# Access Compliance Report

## Public Rights-of-Way

Intersection ID: 28929	Main Street: WADE_ARDREY_RD	Cross Street: CAMPBELL_HALL_CT	Location: NW
ADA ID: 90CB0F26DA87	Ramp Type: PerpDiag	Initial Pass/Fail: Fail	Overall Compliance: No
		Severity Score: 42.5

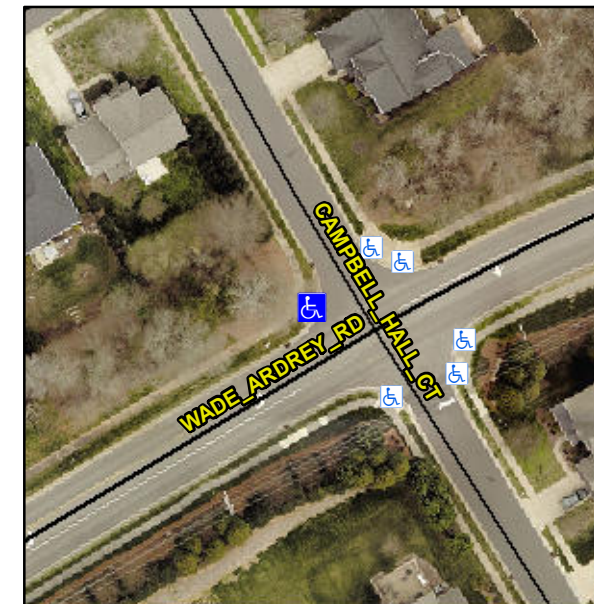
**Not Found, R304.5.1, R304.5.3**

Compliance	Description	Data	Compliance	Description	Data
N/A	Ramp Length (in)	94.0	Yes	Ramp Slope (%)	5.4
No	Ramp Width (in)	32.0	No	Ramp XSlope (%)	8.4
N/A	Flare Type LT	N/A	N/A	Flare Type RT	N/A
N/A	Flare Slope LT (%)	N/A	N/A	Flare Slope RT (%)	N/A
N/A	Flare Traversable LT?	N/A	N/A	Flare Traversable RT?	N/A
N/A	Landing Length (in)	N/A	N/A	DWS Provided?	N/A
N/A	Landing Width (in)	N/A	N/A	DWS Contrast?	N/A
N/A	Landing Slope (%)	N/A	N/A	DWS Length (in)	N/A
N/A	Landing X Slope (%)	N/A	N/A	DWS Full Width?	N/A
N/A	Landing Curb? (Y/N)	N/A	N/A	DWS Offset (in)	N/A
N/A	Shared Landing?	N/A			
N/A	Gutter Ponding?	N/A	N/A	Gutter Slope (%)	N/A
N/A	Gutter Lip Ht (in)	N/A	N/A	Gutter X Slope (%)	N/A
N/A	Painted X Walk1?	No	N/A	Painted X Walk2?	No
	X Walk 1 Direction	To SW		X Walk 2 Direction	To SE
N/A	X Walk 1 Width (in)	N/A	N/A	X Walk 2 Width (in)	N/A
	X Walk 1 Slope (%)	4.2		X Walk 2 Slope (%)	1.5
	X Walk 1 X Slope (%)	4.6		X Walk 2 X Slope (%)	5.5

**Remove & Replace Curb Ramp With Two New Directional Ramps or Equivalent.**
